Advisory Wire

REFERENCE NO:	AW700-25-0780	INFORMATION TYPE:	Maintenance
ATA:	25-74	EFFECTIVITY:	Global 7500 aircraft (70006 – 79999)
SUBJECT:	Towbar Stowage Box – Hinge Pin Migration

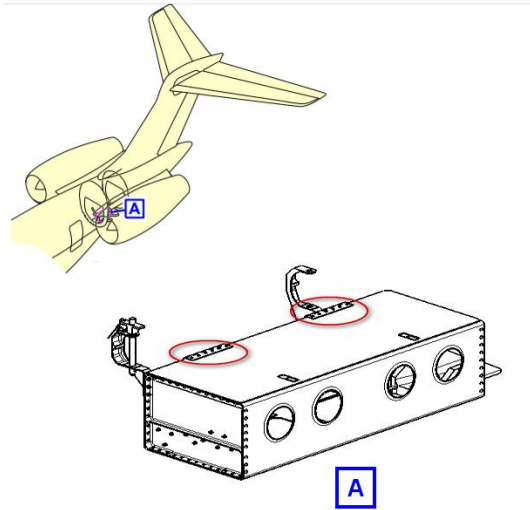
The Global 7500 aircraft is equipped with a towbar stowage box in the aft equipment compartment. The stowage box cover has 2 piano hinges and 2 latches. Bombardier has received reports of the piano hinge pin migrating. In order to prevent risk of damage associated with a loose pin, cover or towbar components, in the aft equipment bay, Bombardier is recommending that operators carry out the SB Ref 1.1 at the earliest convenience within the SB recommended compliance time. The SB recommended compliance time of November 7, 2020 or 50 FH from release date of the SB, whichever comes later, provides flexibility for aircraft not currently flying and/or not accessible to maintenance personnel due to conditions associated with COVID-19 pandemic.

Part A: Removal of the towbar stowage box and its content, thus eliminating the risk of partial detachment and damage to surrounding systems. This option can be used if the tools/capability of performing the modification are not available.

Part B: Modification of the hinges by trimming the hinge pin and adding cotter pins to eliminate the risk of hinge pin migration, allowing for towbar stowage in the aft equipment compartment as originally intended.
